**Agenda item:** ?  
**Source:** Golden Bridge Technology  
**Title:** CLPC on FACH: Responses to Nokia Questions

TSG-RAN Working Group 2 meeting #13  
Oahu, Hawaii, USA  
May 22<sup>nd</sup> – 26<sup>th</sup>, 2000

**R2-001100**

**Agenda item:** Release 2000 issues  
**Source:** Nokia  
**Title:** Questions and comments on the proposed Improved Common DL Channel for Cell FACH State  
**Document for:** Discussion (RAN WG1), Information (RAN WG2)

## FIGURE 1. CLPC FACH Timing.

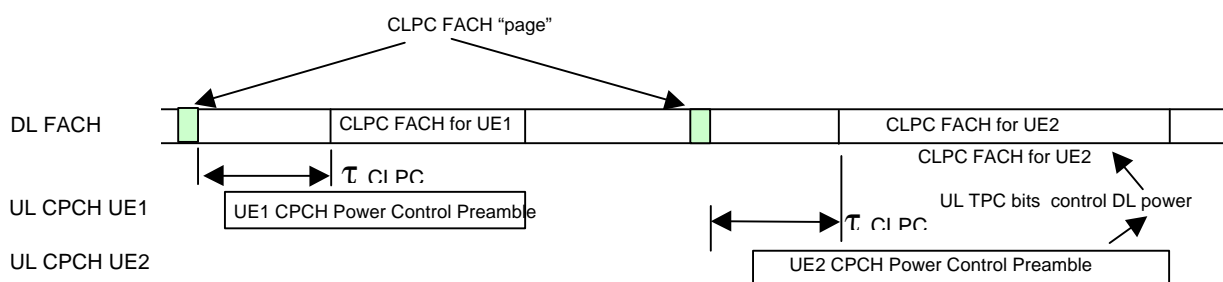
b) What is the minimum and max delay required between FACH "paging" and actual packet on the FACH? What does the calculated delay consist of (UE processing, CPCH procedure, Node B-RNC delay etc.)? Are CPCH procedure error events included?

(5) The scheduling delay,  $\tau_{CLPC}$ , is deterministic and includes

1. UE processing (fixed)
2. CPCH Access Ramp up (variable,  $N_{ap\_retrans\_max}$  dependant)
3. CD phase ( fixed)
4. pre-data power control (fixed)

Note that 1 or two PCPCH channels are reserved for CLPC and there is no contention for this PCPCH. CPCH procedure errors events are considered in this protocol and if they occur, OLPC of FACH (normal operation) is used on the FACH segment. See answer (9), below.

$$\tau_{CLPC} = (N_{ap\_retrans\_max} + 1)\tau_{next\_slot} + 5.28msec,$$

where  $\tau_{next\_slot}$  = Time to next available access slot, between Access Preambles.

$$= 3.75ms + 1.25ms \times T_{cpch} \quad (\text{CPCH timing parameter})$$

Note that this is equivalent to:

$$\tau_{CLPC} = [\text{max period from first AP to start of PCP}] + [8 \text{ slot length PCP}]$$

Figure 1 below shows an overview of the CLPC FACH timing between the Node B and the UEs.

For example if  $T_{\text{next slot}} = 3.75 \text{ msec}$ , and if  $N_{\text{ap\_retrans\_max}} = 10$ ,  
 $\tau_{\text{CLPC}} = (10 + 1) * 3.75 + 5.28 \text{ msec} = 46.5 \text{ msec}$  (approximately 5 frames).
